WRJO – Replace Front Left and Right Seat and Backrest Heating Element (Stop Delivery)

Model Line: **911 (992)**

Concerns: **Heating element for front seat and backrest**

Installation position for seat and backrest padding

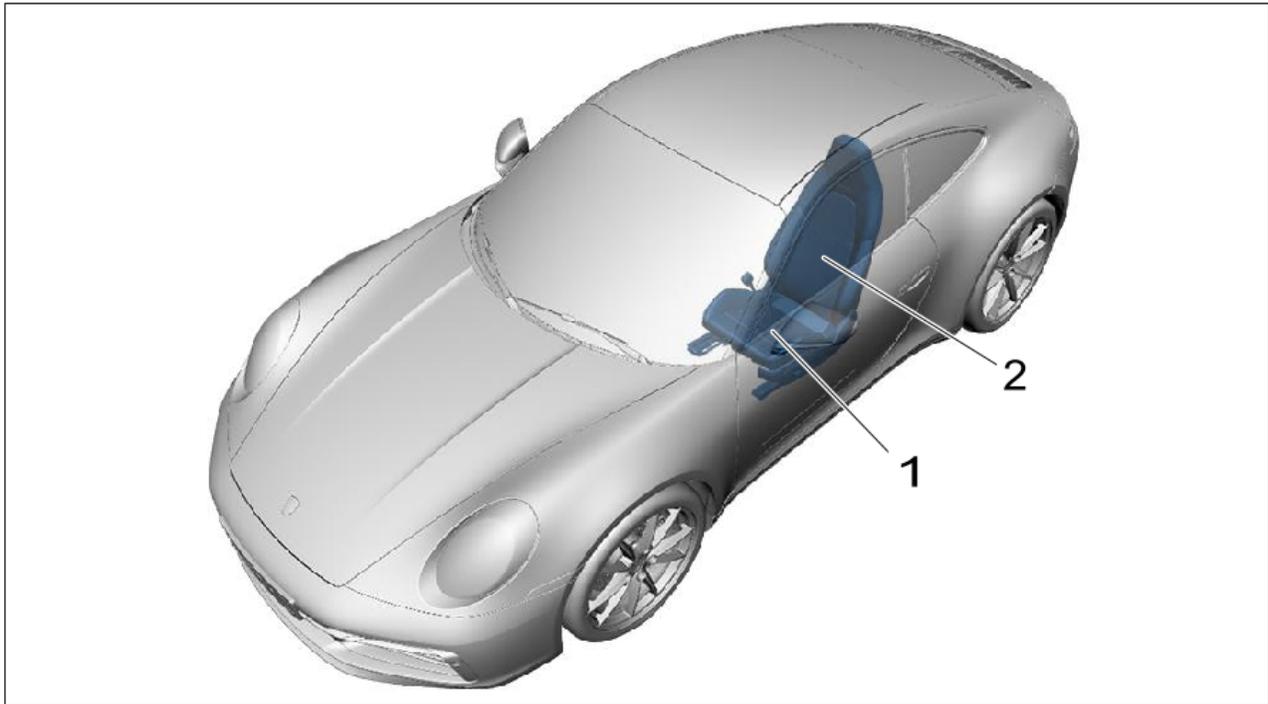
Cause: **The heating elements in the front seats and backrests of the affected vehicles may not have been manufactured to specification.**
 For this reason, when the seat heating is activated, excessive heat may develop at certain points. This may result in a risk of injury or damage to the seat cover.

Action: **Replace front left and right seat and backrest heating element.**

The heating element for the front seat and backrest is integrated into the padding for the front seat and backrest and cannot be replaced separately. To replace the seat/backrest heating element, the entire seat/backrest padding must be replaced.
